## **NEWS**Aftermarket 0

AM02 / 2017

## **Amendment of repair kits**

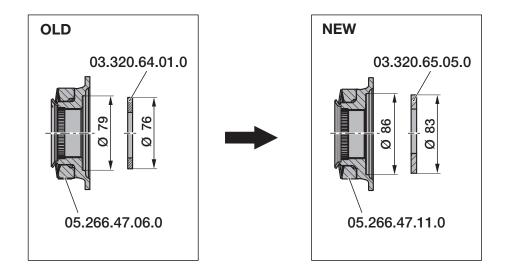
09.801.06.26.0 -> 09.801.06.26.1

09.801.06.27.0 -> 09.801.06.27.1

09.801.07.04.0 -> 09.801.07.04.1

To avoid incorrect assembling the a.m. new repair kits will not contain the thrust washer 03.320.64.01.0.

In 2014, the combination of axle nut 05.266.47.06.0 with thrust washer 03.320.64.01.0 has been replaced by the combination of axle nut 05.266.47.11.0 with thrust washer 03.320.65.05.0.

A different combination of axle nut and thrust washer as explained above is not permitted. Incorrect assembling may cause further damages!
